# **Albany Highway Bedfordale Hill section duplication**

**Main Roads Western Australia**

**Report and recommendations  
of the Environmental Protection Authority**

**Environmental Protection Authority  
Perth, Western Australia  
Bulletin 837  
December 1996**

Figure 2. Bungendore Park — System 6 M80 (Source: EPA, 1983).

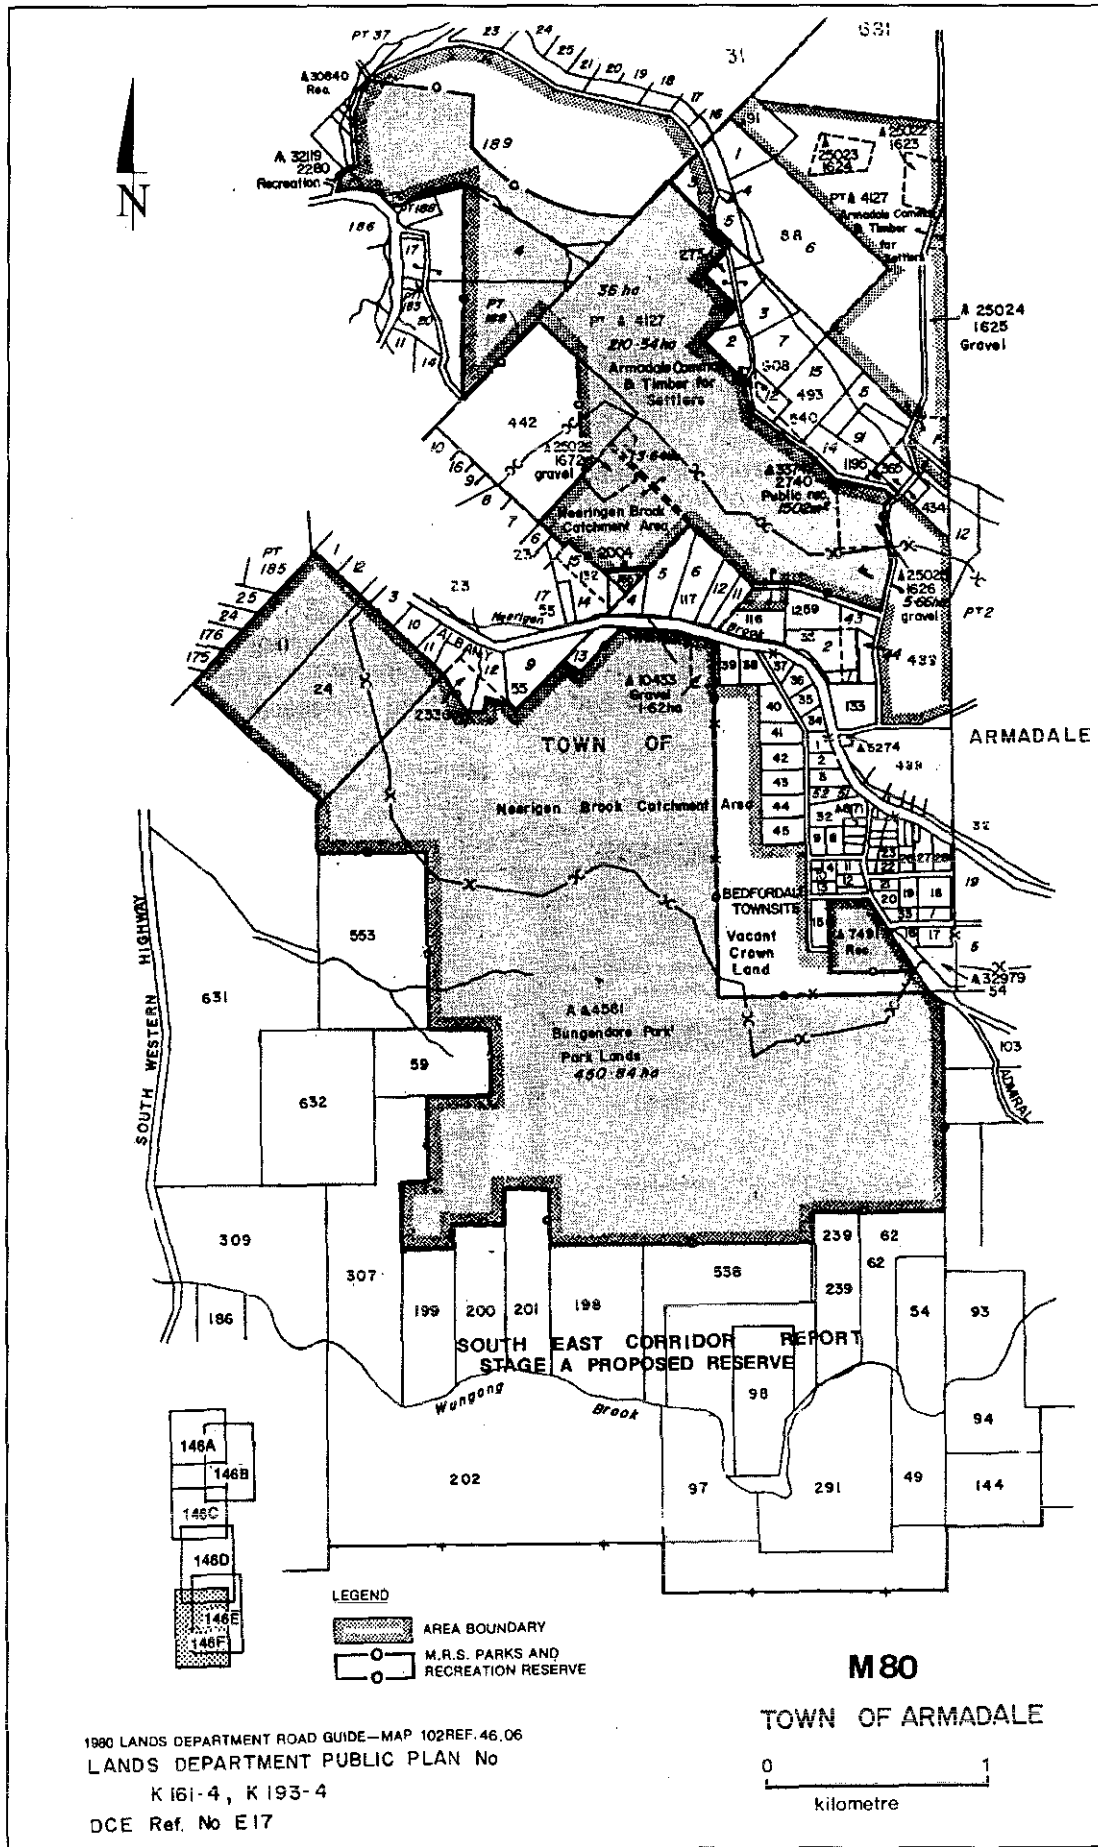
The earthworks of the proposed carriageway encroach onto Bungendore Park which is part of System 6 Recommendation M80 - Darling Scarp (EPA, 1983) (Figure 2, Appendix 1). Recommendation M80 relates to several areas in the Darling Scarp and recognises that one of the most important parts of M80 floristically, is the southern and western slopes of Bungendore Park (EPA, 1983, p.260). Bungendore Park also supports a rare species of dryandra, *Dryandra praemorsa*.

The area considered for assessment of this environmental factor is Bungendore Park (Appendix 1: Figure 2). This is an identifiable unit which is part of the existing conservation estate and supports significant flora and fauna.

The EPA notes that the proponent has not made commitments specifically relating to Southern Brown Bandicoot habitat. It is considered, therefore, that a fauna survey should be undertaken to the satisfaction of CALM to determine if the area of impact includes Southern Brown Bandicoot habitat. The results and mitigation methods should be included in the EMP to the requirements of CALM.

- (a) The proponent should be required to implement the EMP as detailed in the CER (Ecologia, 1996) subject to the following provisions:
- the results of Declared Rare Flora and protected fauna surveys undertaken by the proponent and associated mitigation measures, should be included in the CER and implemented to the satisfaction of CALM;

Figure 3. Extent of impact on Bungendore Park (Source: MRWA, 1996).

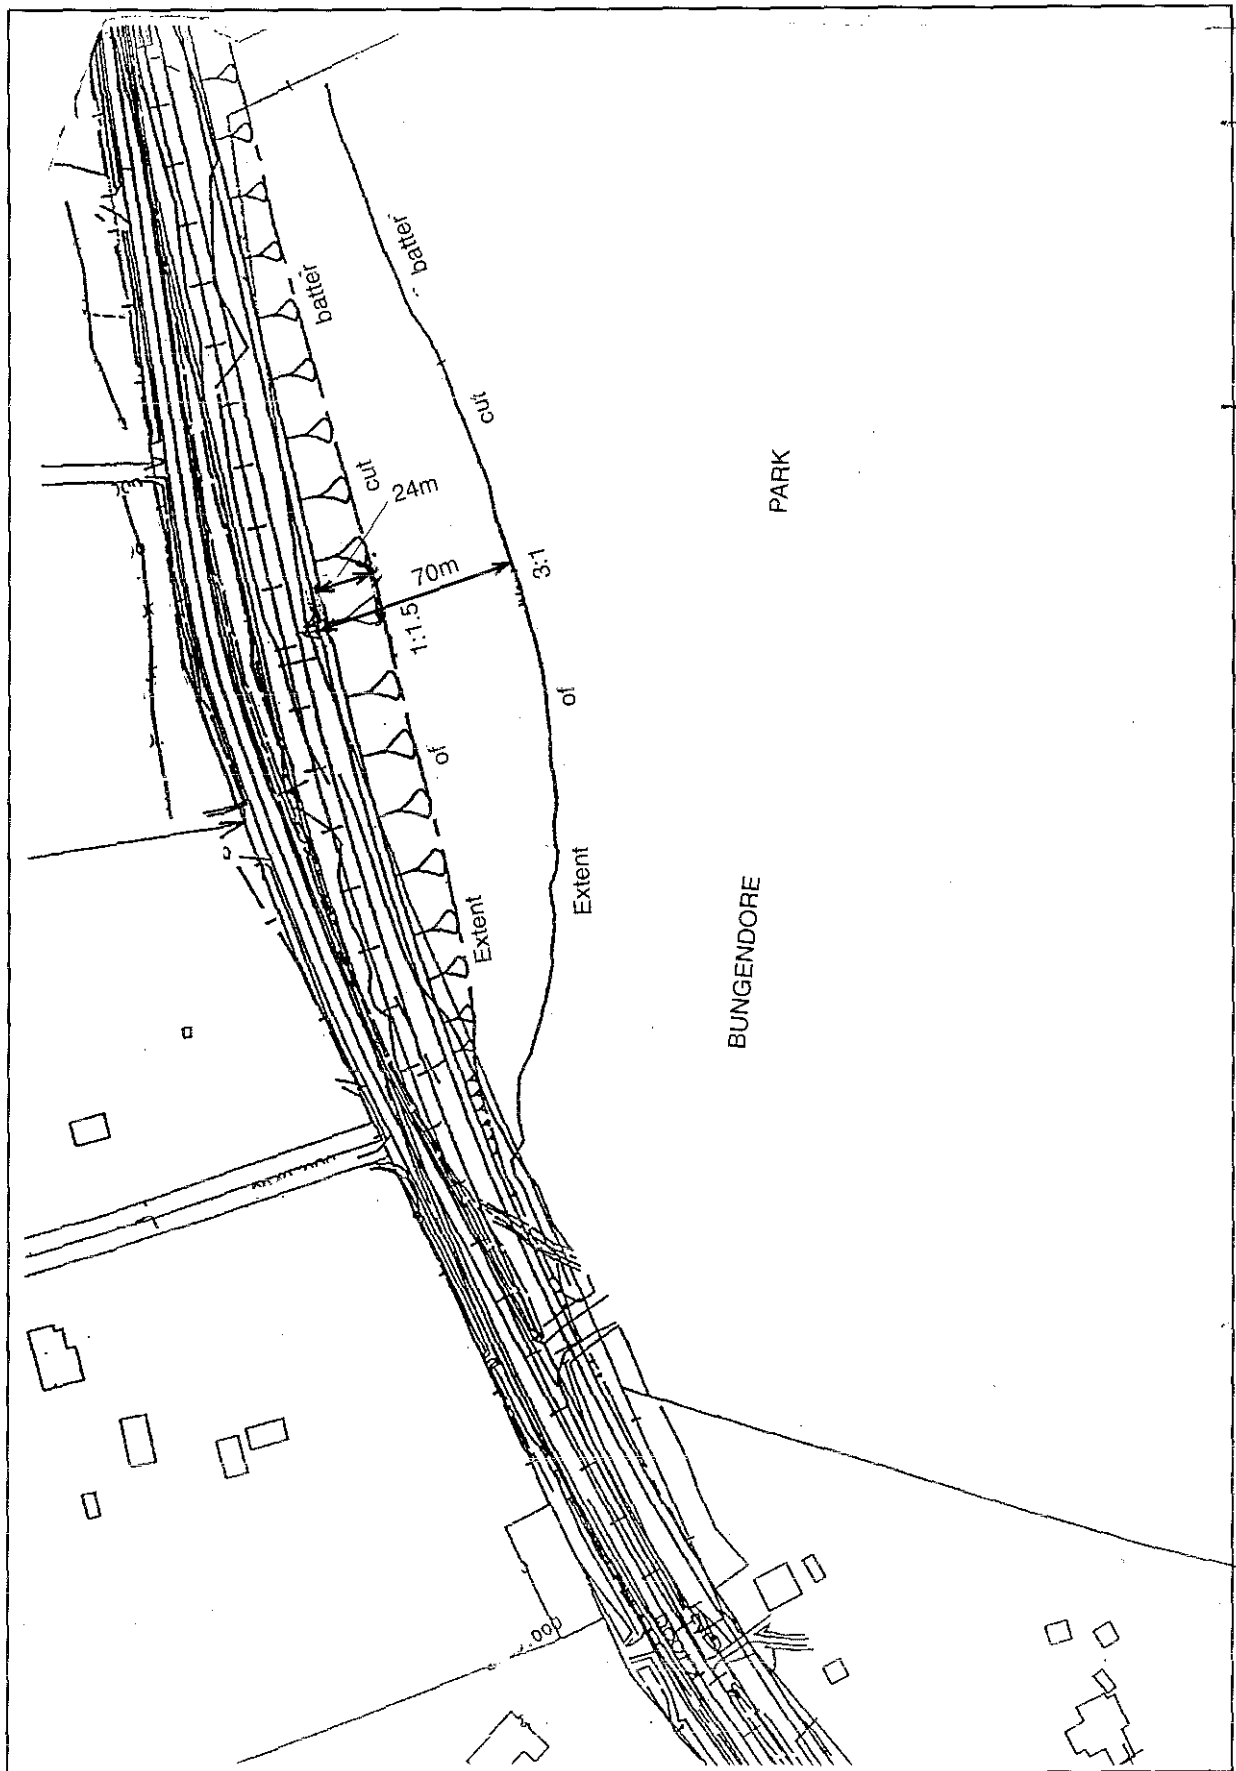
Both the City of Armadale and BPMC have requested that the road batters, for the section of carriageway encroaching on the park be no flatter than 1.5:1 to limit intrusion into the park. The BPMC has also provided advice regarding protected fauna in the park, suitable species for rehabilitation, and measures for weed control.

In order to further reduce the impact on the park, the proponent has agreed to increase the batter gradients adjacent to the park from 3:1 to 1.5:1 consistent with the requests of the City of Armadale and BPMC. This decreases the encroachment from 70 metres to 24 metres (Appendix 1: Figure 3). The proponent has also made a commitment to reduce the extent of clearing by demarcation of the limit-of-works on construction drawings and ensuring that it is adhered to (Ecologia 1996a, p37), and has committed to rehabilitate the area of impact by revegetating the road batters with native species.

Figure 4. Extent of proposed deviation of Neerigen Brook (Source: MRWA, 1996).

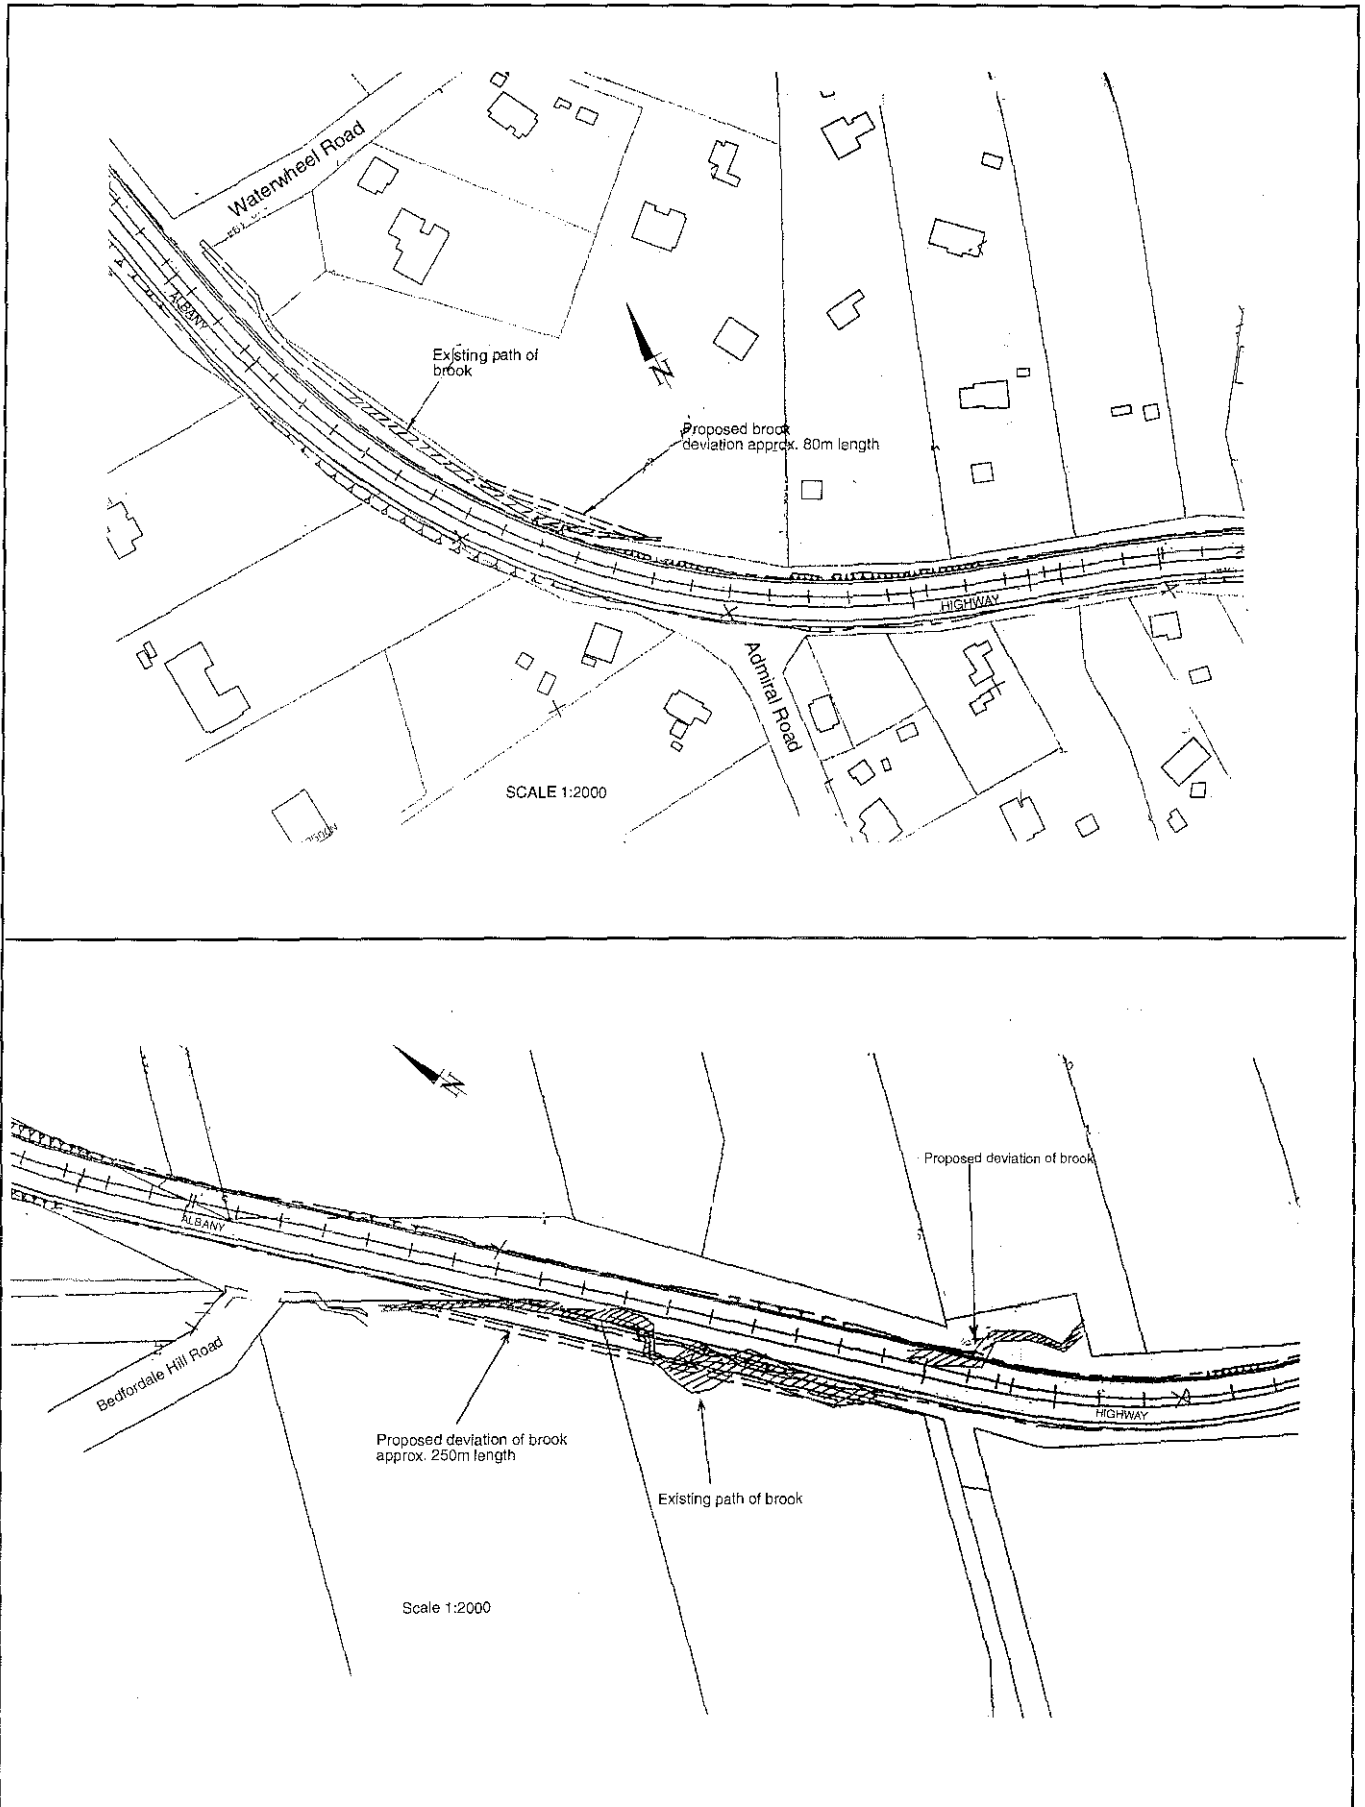
Neerigen Brook will be deviated at two locations to permit construction of the road (Appendix 1: Figure 4). These are:

- (a) South of Bedforddale Hill Road: a new channel will be constructed 10 meters west of the existing channel, 250 meters in length to where the Brook crosses beneath Albany Highway; and
- (b) North of Admiral Road: Approximately 80 meters of the existing channel will be relocated 5 meters east of its existing alignment.

The proponent has committed to confirm the hydrological characteristics of Neerigen Brook, in order to design the sections requiring realignment in accordance with existing channel parameters, and will include pool and riffle sequences in stream rehabilitation (including revegetation) where possible. The proponent has agreed to consult with WRC with respect to these commitments and will amend the EMP for the proposal to accord with WRC requirements.

- the details of Neerigen Brook deviations and rehabilitation, and erosion/siltation control should be included in the EMP and implemented to the satisfaction of the WRC;
